MIL-C-38214B (USAF)
AMENDMENT 4

MILITARY SPECIFICATION

COMPASS, MAGNETIC, MOUNTED

This amendment forms a part of MIL-C-38214B(USAF), dated 7 October 1968, and is approved for use within the Department of the Air Force and is available for use by all Departments and Agencies of the Department of Defense.

FIGURE 4 Environmental cycling

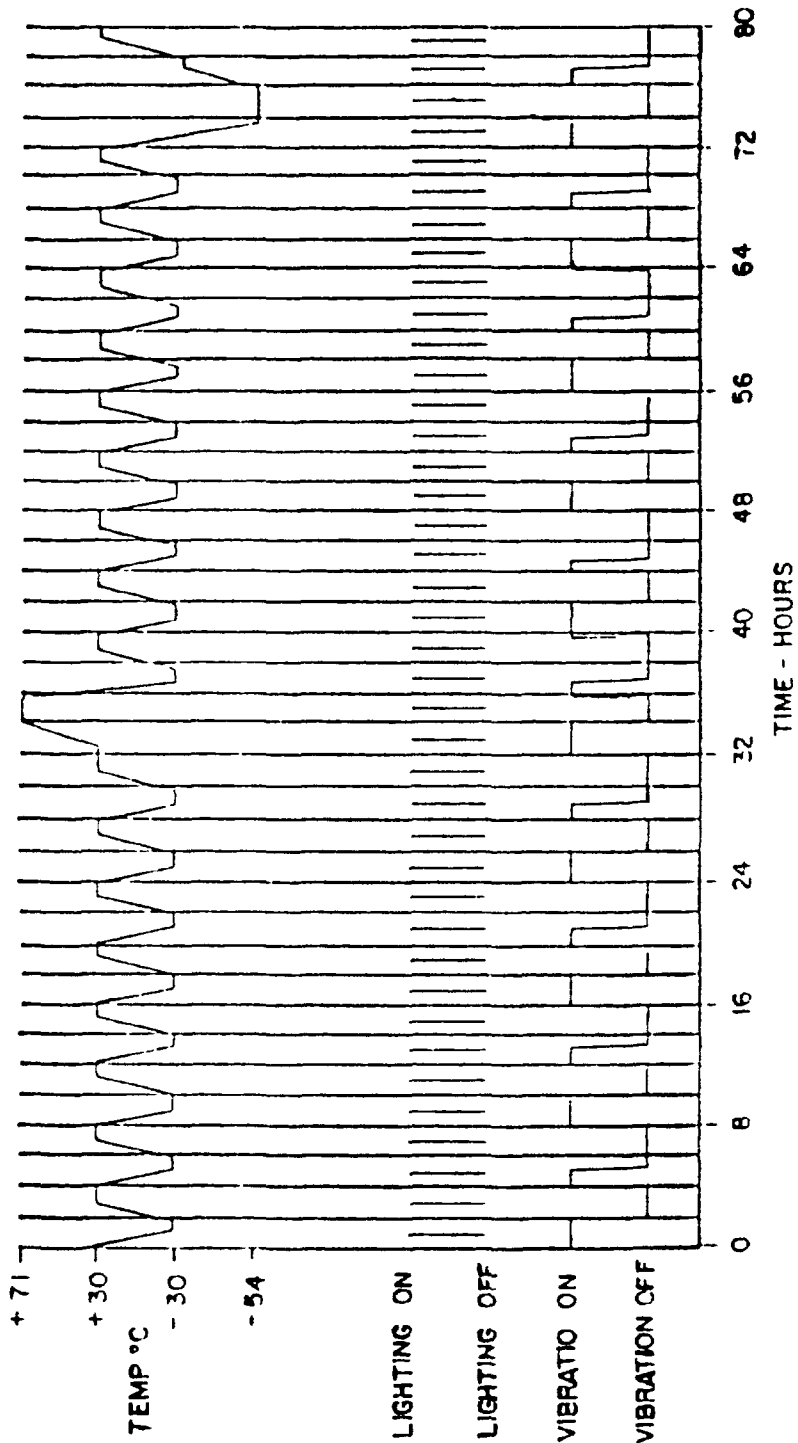
4.5.2.4.1 Line 1 delete "Figure 4" and add: "MIL-STD-781C, Test Plan IC as modified by the following". Line 9, change "31,400" to read "30,240".

Figure 4. Delete and add. new figure 4.

4.6.29 Add the following before sentence one of existing paragraph: "Testing shall be in accordance with MIL-STD-781C, Test Plan IC (modified). Modification shall be in accordance with contents of paragraph 4.5.2.4.1 herein. Lines 2 and 5, existing paragraph, delete "figure 5" and add: "figure 4". Last line, change "the compass shall" to read "each compass shall also."

* 4.6.29.1 Delete "figure 5" in line 2 and add: "figure 4."

* 4.6.29 Line 2 delete "figure 5" and add: "figure 4."
